Product Change Notice (PCN)

PCN Number: **PCN-0450879R-01**

Product(s) Affected: **PJ1-021**

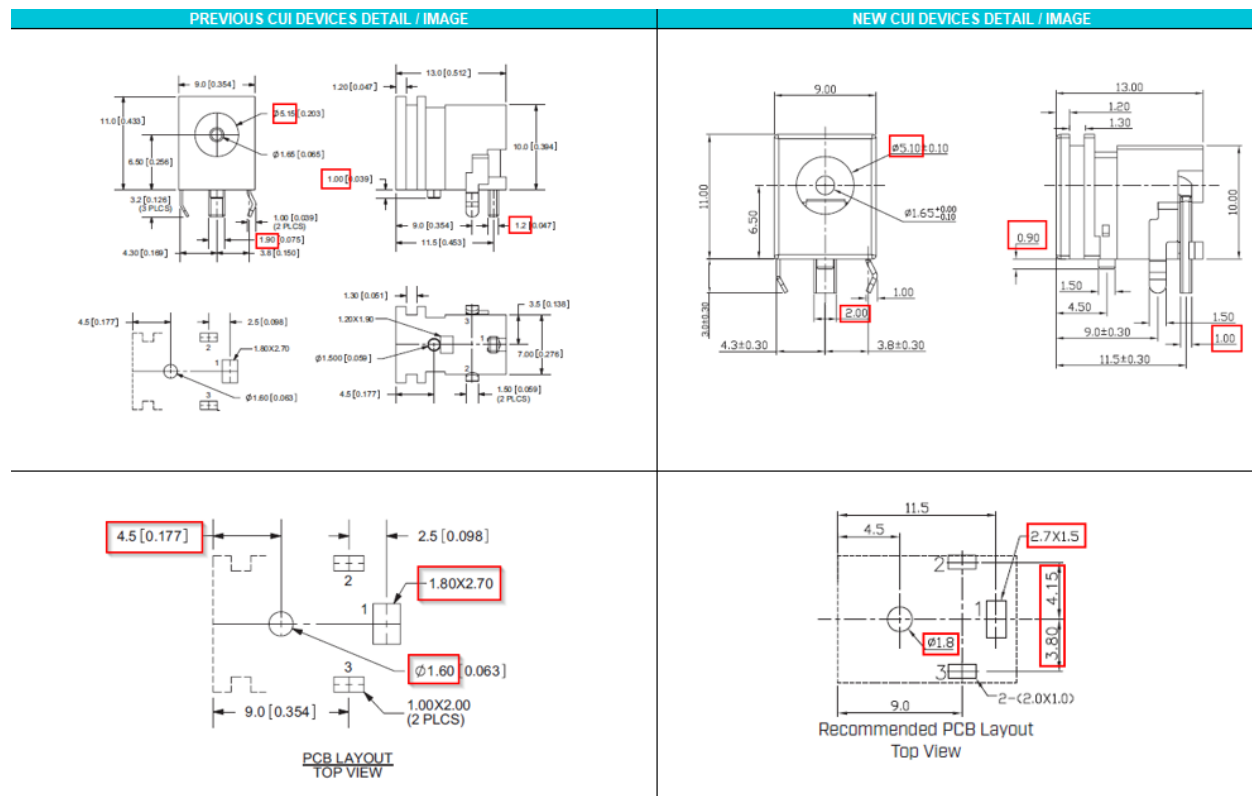
Description of Change: **Minor Housing and footprint differences. Material Change on the housing and terminals. See image Below**

PREVIOUS CUI DEVICES DETAIL / IMAGE			NEW CUI DEVICES DETAIL / IMAGE			
	MATERIAL	PLATING		DESCRIPTION	PLATING/COLOR	
center pin	copper	silver		center pin	brass	nickel
terminal 1	copper	silver		terminal 1	brass	nickel
terminal 2	copper alloy	silver		terminal 2	bronze t=0.30	silver
terminal 3	brass	silver		terminal 3	brass t=0.40	silver
plastic	PBT			housing	PBT (UL94V-0)	black

<p>MATING PLUG Jack Insertion Depth: 8.5 mm</p>	 <p>MATING PLUG Jack Insertion Depth: 8.7 mm</p>
---------------------------------------------------------------------------------------------------------------------------------------	----------------------------------------------------------------------------------------------------------------------------------------
